ADDENDUM

CITY OF AMES

PROJECT: 2019-20 Storm Water Erosion Control Program (Ioway Creek at Brookside), Project No. 560-8636-489

ADDENDUM NUMBER: 1

ADDENDUM 1:
PLAN VIEW

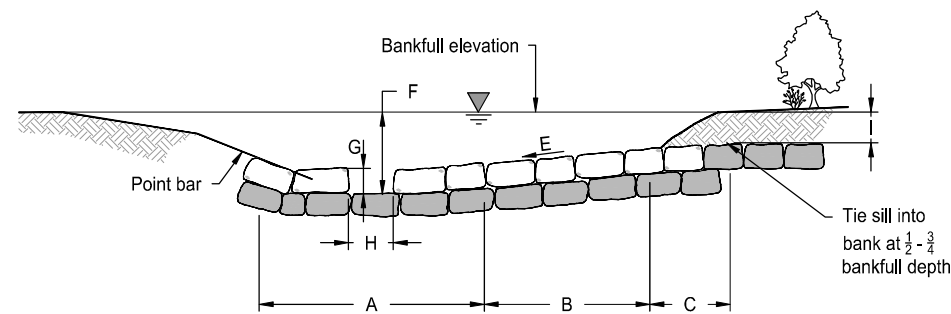
1. **SHEET B.06**

Bidders shall use the attached Revised Plan Sheet B.06. The nature of the change is to define the term "bankfull depth".

Bankfull depth is equal to the bankfull elevation minus the proposed channel bottom elevation.

NOTE: Refer to nearest cross section in W.01-W.06 for bankfull elevations.
